Product Change Notification

Change Notification #: 114428 - 02
Change Title: Intel® Server Systems R2308WTTYSR,
Intel® Server Systems R2312WTTYSR,
Intel® Server Systems R2000WTXXX,
Intel® Server Systems R2208WT2YSR,
Intel® Server Systems R2208WTTYC1R,
Intel® Server Systems R2208WTTYSR,
Intel® Server Systems R2224WTTYYS,
Intel® Server Systems R2224WTTYYSR,
Intel® Server Systems R2308WTTYYS,
Intel® Server Systems R2312WTTYYS,
Intel® Server Systems R2312WTXXX,
Intel® Server Systems SDP2308BWTT,
Intel® Server Systems SDP2308SWTT,
Intel® Server Systems SDP2308WTTAPP,
PCN 114428-02, Product Design,
Cover added to rear panel DB9 hole
connector, added paint specification applying
to R2312WTTYSR only
Reason for Revision: Adding products to the
Products Affected/Intel Ordering Codes table

Date of Publication: March 17, 2016

Image 1 “DB9 rear panel hole”

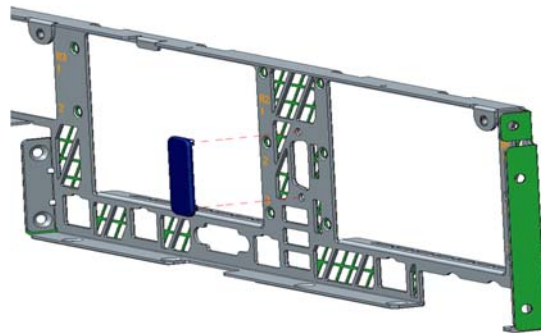
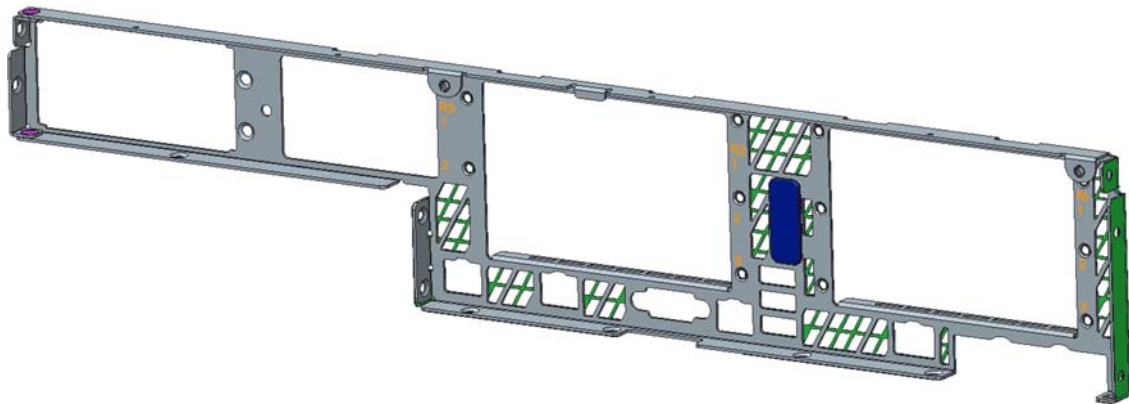
1. Add paint specification to rack ears only for Intel® Server System R2312WTTYSR.
2. Add a new cover in the rear panel for the DB9 connector on 2U S2000WT systems.
 - a. Image 1 shows the DB9 rear panel hole that is going to be covered
 - b. Image 2 shows the DB9 rear panel hole after the cover is installed
 - c. Image 3 shows the DBA cover.
